This is in regards to the Coastside Design Review Committee meeting September 12, 2024 agenda item 2, Elizabeth Lacasia file PLN2021-00478, 779 San Carlos Ave, APN 047-105-020

Response to Coastal Design Review 779 San Carlos - Introduction

This response is from Kathleen and Richard Klein, owners of the adjacent house at 771 San Carlos Ave.

SHEET TITLE:
GENERAL NOTES AND LEGEND

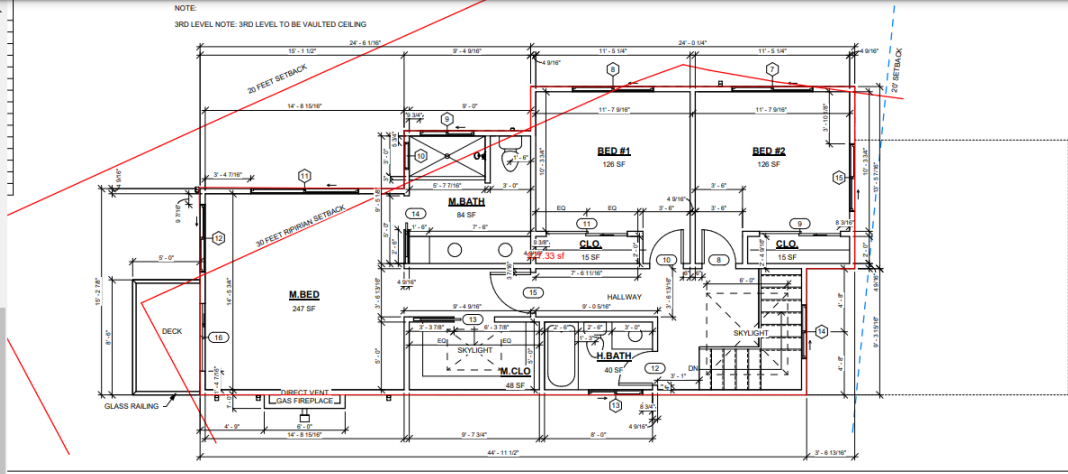
The plans on file show many intrusions into the buffer zone, mostly from higher stories.

This rendering shows the balconies, deck, and extensions, mostly from the top floor.
